HISTORIC AND DESIGN REVIEW COMMISSION

September 06, 2017

HDRC CASE NO: 2017-425
ADDRESS: 1108 S FLORES ST
LEGAL DESCRIPTION: NCB 2556 BLK A LOTS 3 TO 7
ZONING: C-3NA, H
CITY COUNCIL DIST.: 1
DISTRICT: Nathan Historic District
APPLICANT: Scott Glenn
OWNER: Jeremy Jessop/Tobin Equity Real Estate, LLC
TYPE OF WORK: Exterior modifications, roof top addition, fenestration modifications and signage
REQUEST:

① Alley Elevation Copy 1
1/16" = 1'-0"

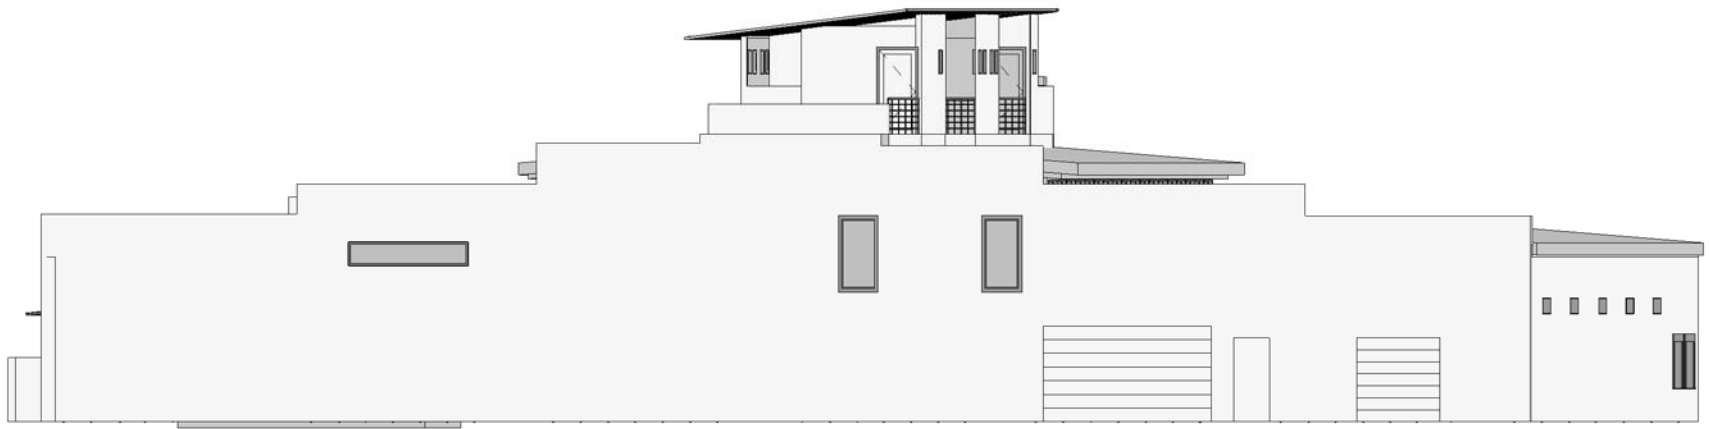
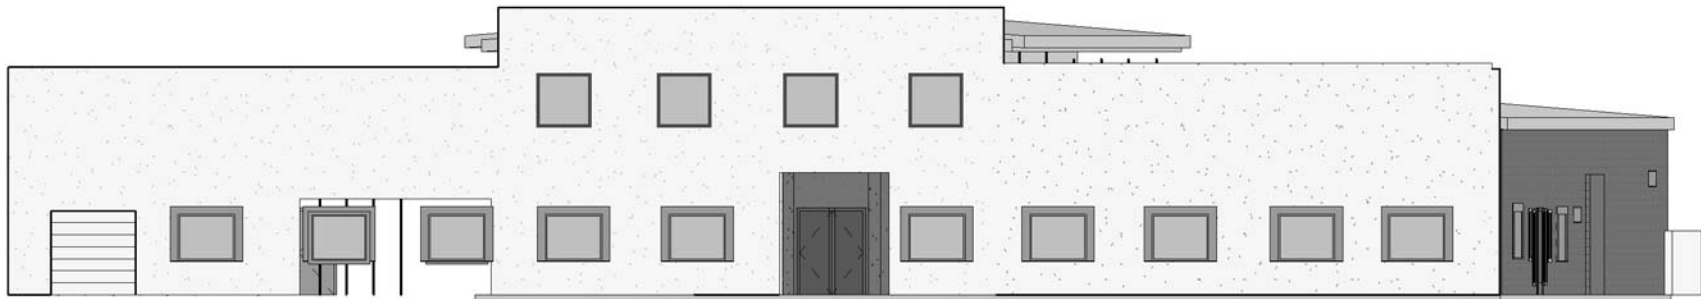
- c. EXTERIOR MODIFICATIONS (Alley) – On the alley façade, the applicant has proposed the modifications that include the removal of one pedestrian door opening and the installation of two overhead rolling doors, a new pedestrian door opening and three windows. Given the location of this façade at an alley and not visible from S Flores, staff finds these modifications appropriate. The proposed window openings should feature windows with a profile consistent with those of industrial structures of this era. The proposed rolling doors should feature high quality materials. Vinyl or a composite material should not be used.

- i. That high quality, overhead rolling door are installed that do not feature vinyl or composite materials.
- ii. That proposed window openings should feature windows with a profile consistent with those of this structure.
- iii. That The rooftop design feature either a greater setback or modified roof form to improve compatibility with the S Flores façade.
- iv. That the addition feature materials and textures that are complementary to those of the historic structure.
- v. That the proposed signage feature indirect or back lighting and that vinyl or plastic sign faces are not used.

② South Flores Elevation Copy 1
1/16" = 1'-0"

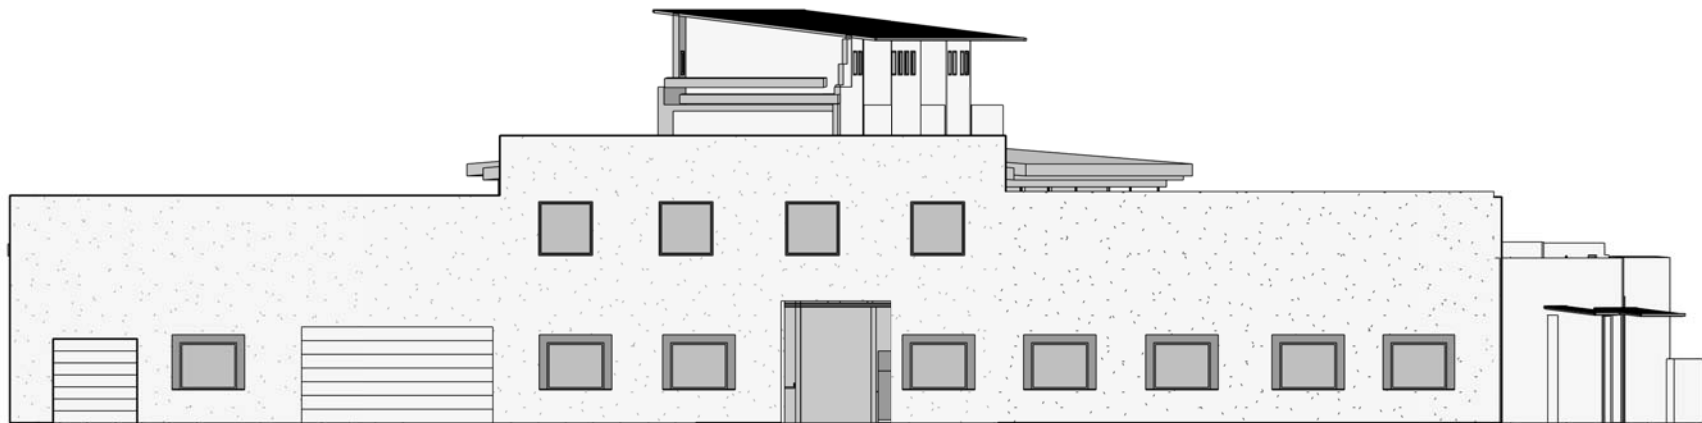
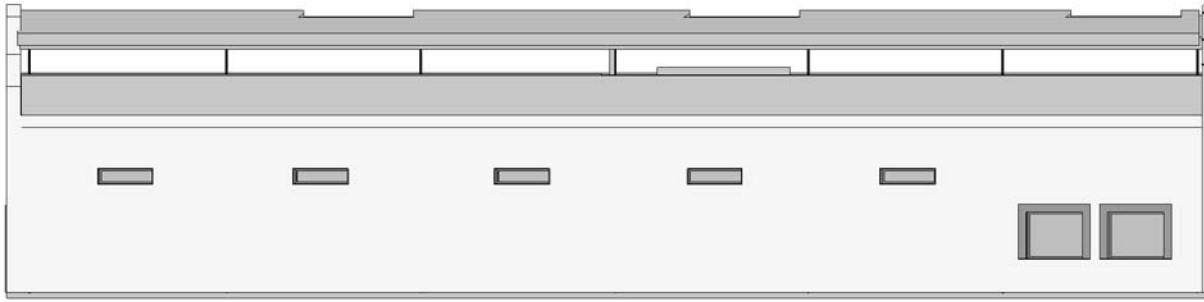
- b. EXTERIOR MODIFICATIONS (S Flores)— The applicant has proposed exterior modifications that include the installation of two rolling garage doors on the S Flores façade. A smaller rolling garage door would be installed in an existing pedestrian door opening while another would replace two existing window openings on the S Flores façade. The applicant has proposed this location for automobiles to exit the structure on S Flores. Staff finds the removal of the non-original façade openings that be appropriate; however, a high quality overhead rolling door should be installed in this opening. Vinyl or a composite material should not be used.

① Daniel Street Elevation Copy 1
1/16" = 1'-0"

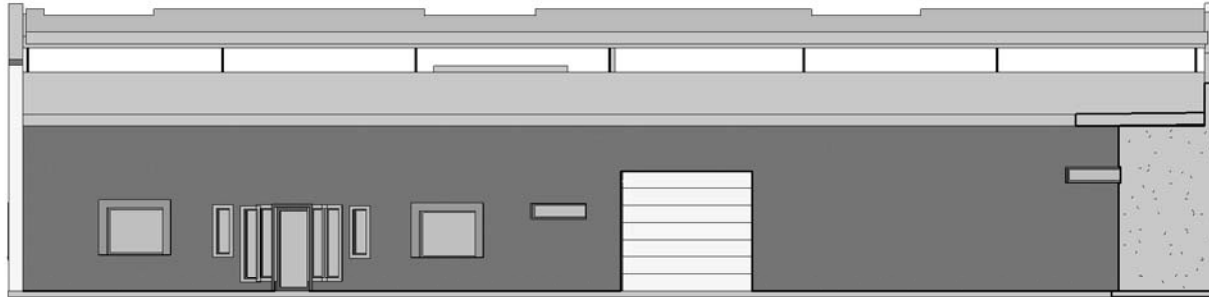
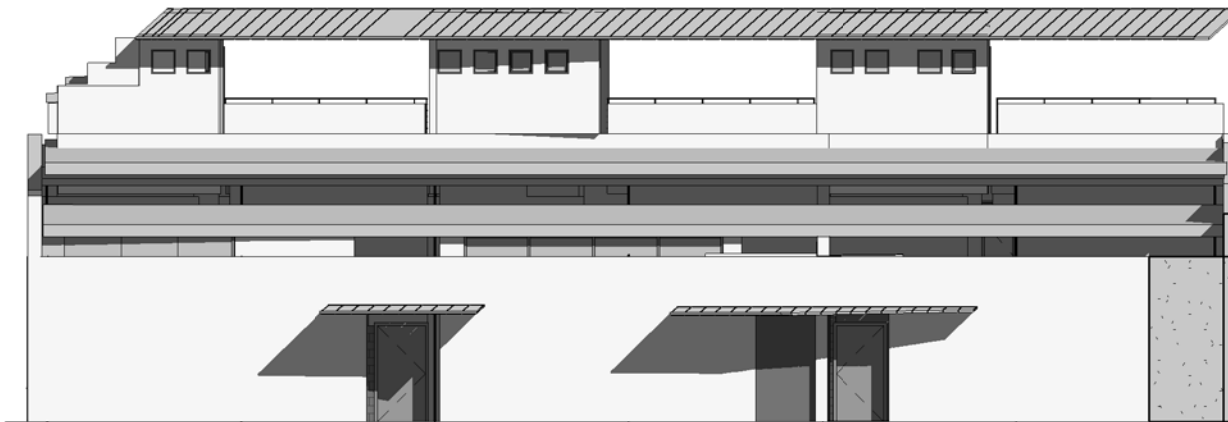
- d. EXTERIOR MODIFICATIONS (Daniel) – On the Daniel elevation, the applicant has proposed to remove six existing window openings, one pedestrian door and its associated side lights and an overhead rolling door and install three pedestrian entrances and overhead canopies. Staff finds the proposed modifications to be appropriate and consistent with the overall architectural character of the building. Additionally, the proposed entrance canopies are simple in nature, consistent with the architecture of the existing structure.
